# SERVICE BULLETIN NO. 107

Section VIII, Div. A  
Service Bulletin 107  
Issued May, 1976

SUBJECT: RECOIL STARTER CENTER SCREW SIZE CHANGE

SCREW PART NO. 258-1103

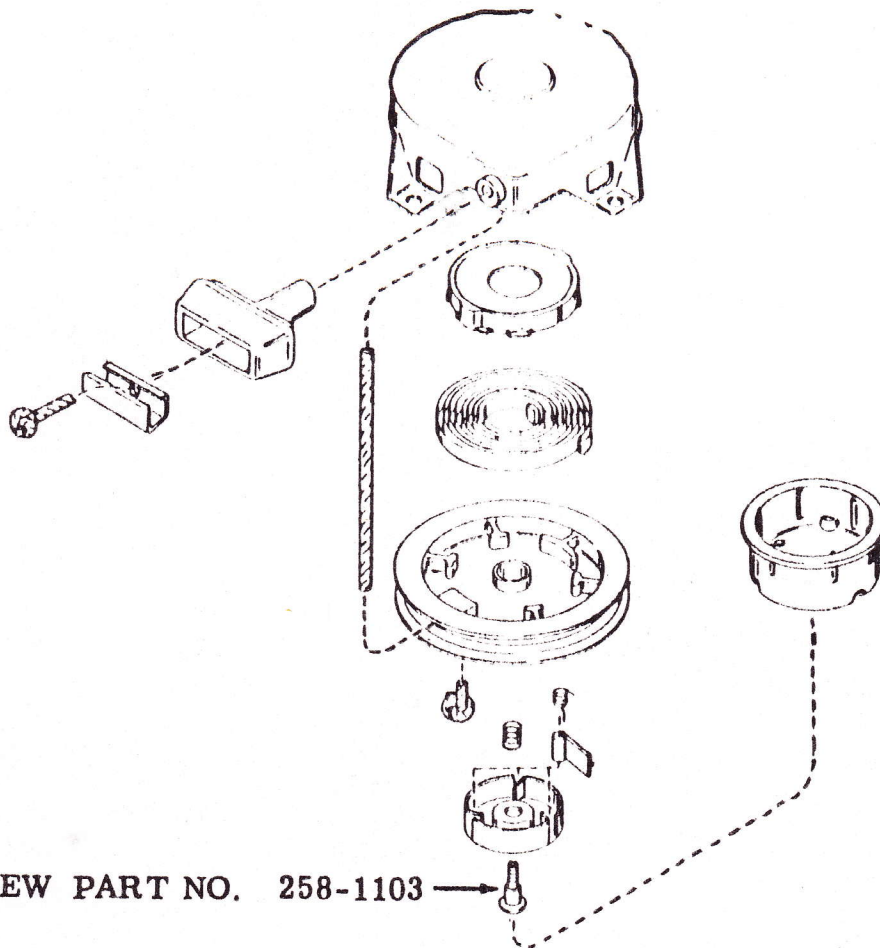
On older model engines using the above Recoil Starters center screw part no. 258-1103 was a #10-32 thread. Later model engines with the above Recoils will be using a screw with a #12-28 thread.

The part number on the screw will not change, and our factory service stock will be changed at once to the #12-28 thread screw.

To service Recoil Starters having the #10-32 screw, it will be necessary to drill out the center hole in the Recoil Starter Housing post with a 13/64 drill.
